COORDINATED DEVELOPMENT TILGHMAN HOLDINGS

MAJOR PLAN 2024-102

SUBJECT: COORDINATED DEVELOPMENT TILGHMAN HOLDINGS
MAJOR PLAN 2024-102
PRELIMINARY/FINAL PLAN REVIEW

SUBJECT: South Whitehall Township
Tilghman Holdings, LLC – Phase 1
Major Plan #2024-102
Preliminary/Final Plan Review

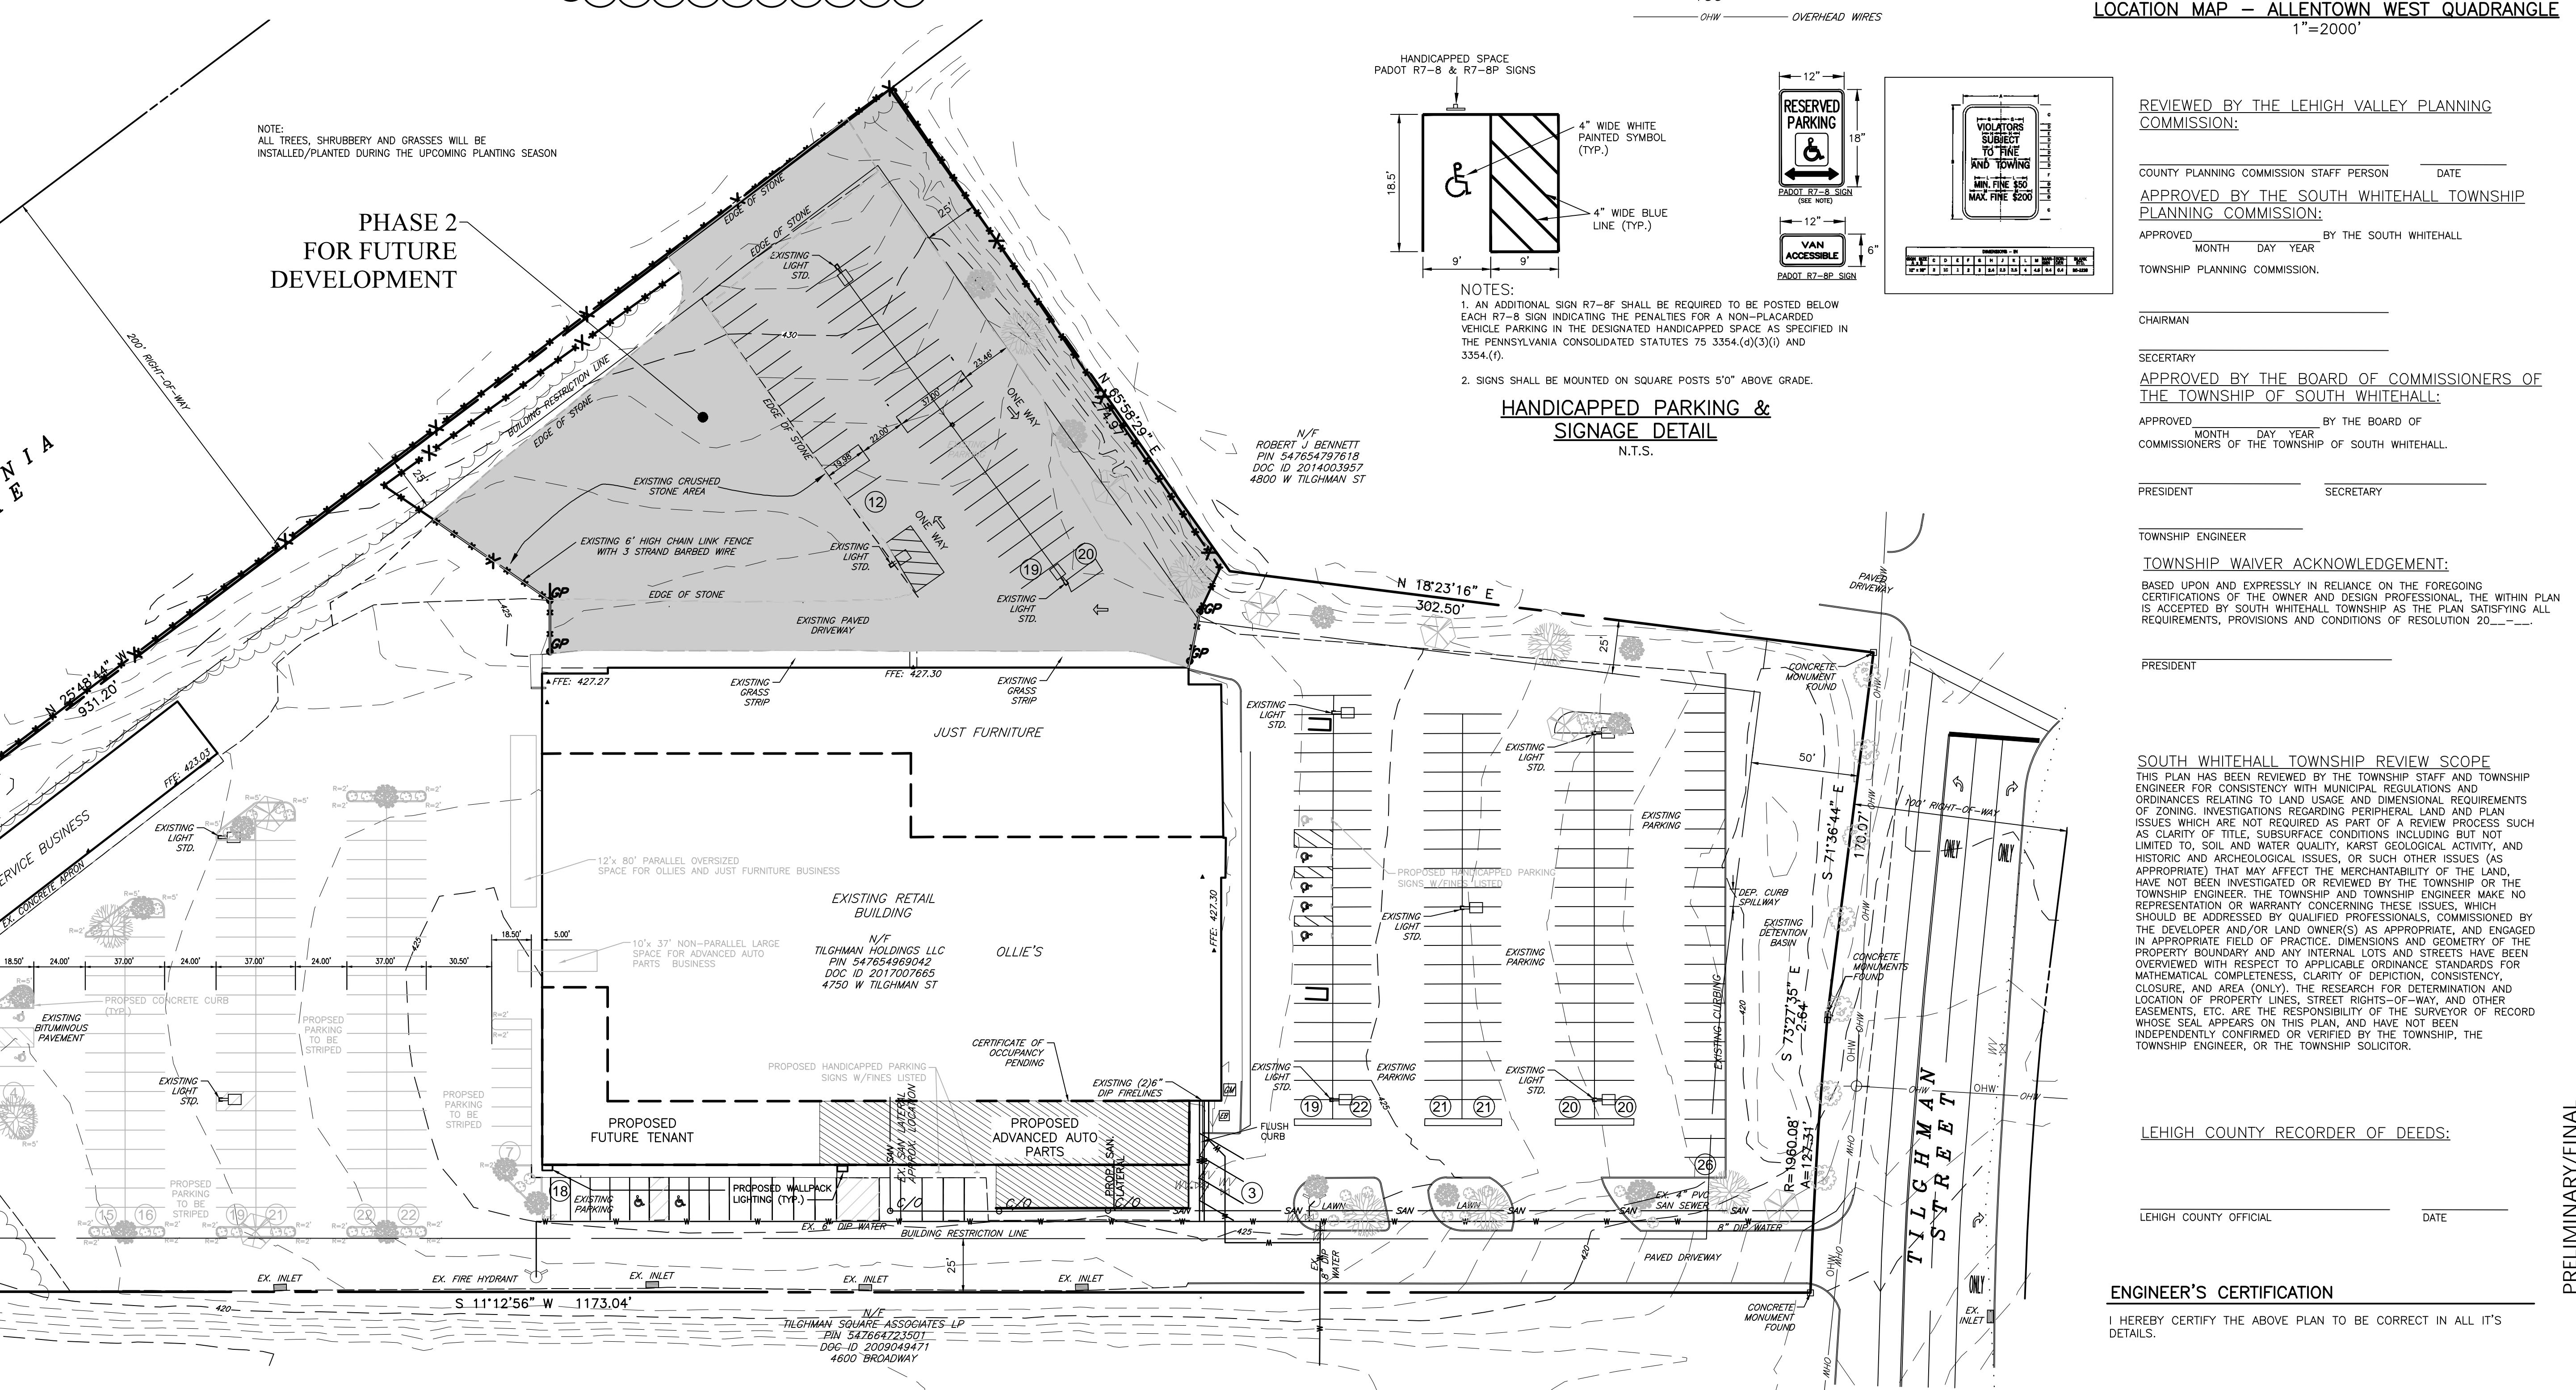
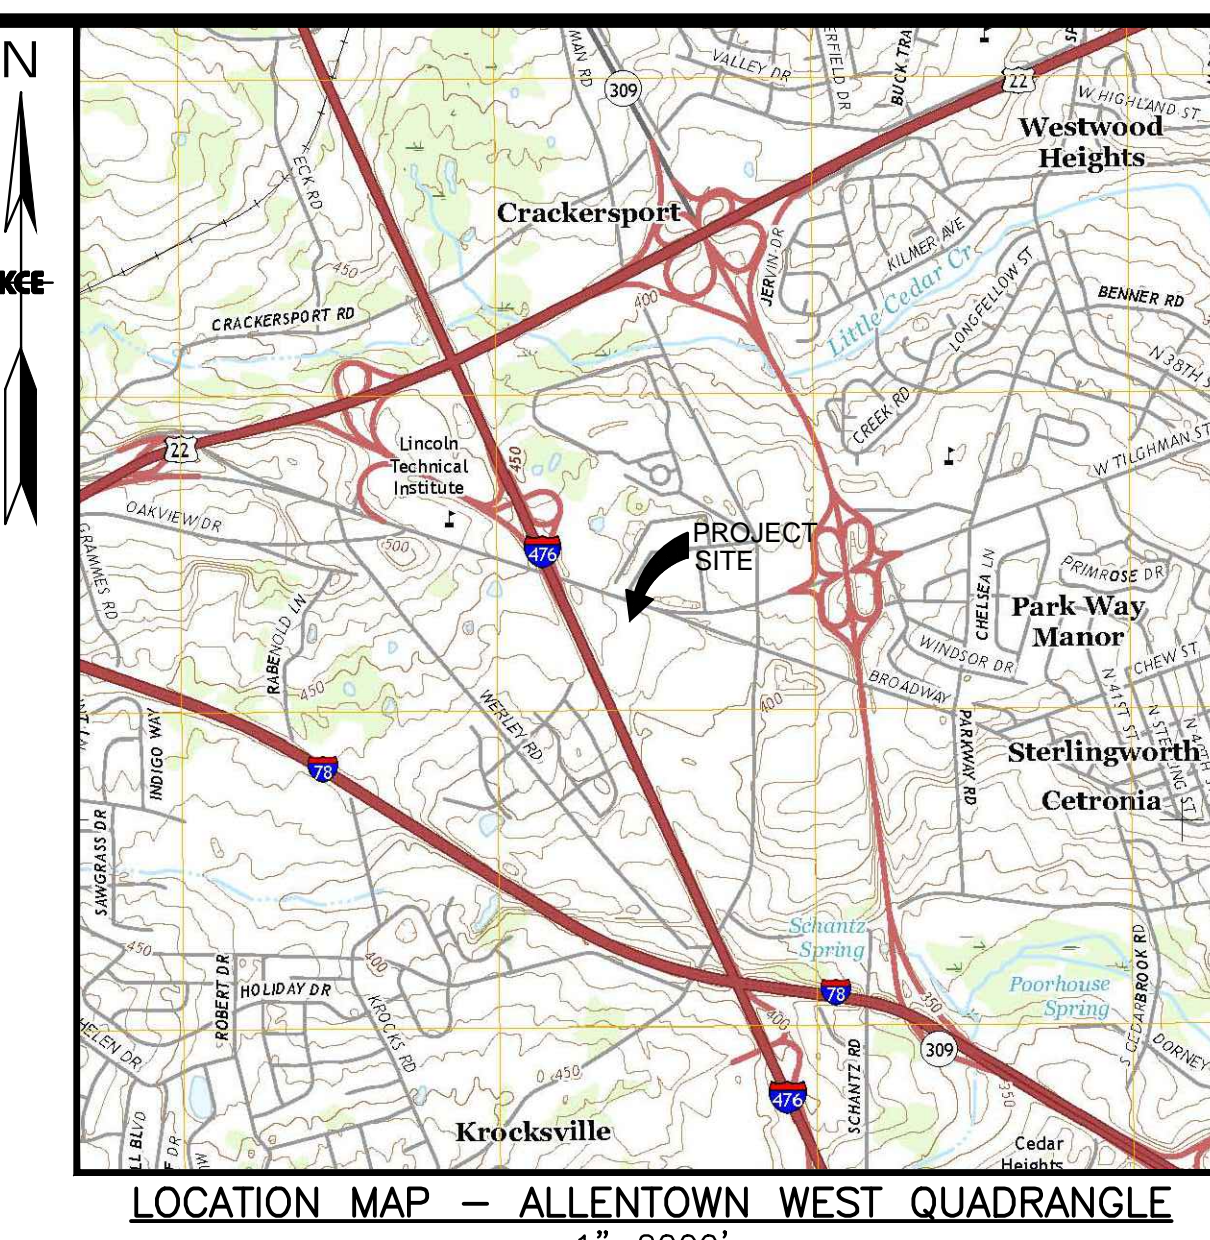
1. Address any concerns of the Landscape and Shade Tree Commission, SALDO §312-12(b)(28) and §312-12(b)(36). We note that previously approved landscaped islands (Sheet 1) in the southern parking area have been removed from the current layout (Sheet 2);
2. The Township should determine whether open space, or fees in lieu thereof, will be required, and an appropriate note added to the plan to be recorded, SALDO §312-34(d) and §312-36(d);
3. Provide a note listing all required outside agency permits and approvals on a plan to be recorded. These Agencies/permits include, but may not necessarily be limited to:
 - a. LVPC, SALDO §312-12(a)(10) and §312-14(a)(6);
 - b. PennDOT, SALDO §312-12(a)(11) and §312-14(a)(7); and
 - c. PADEP, SALDO §312-12(a)(12) and §312-14(a)(8).
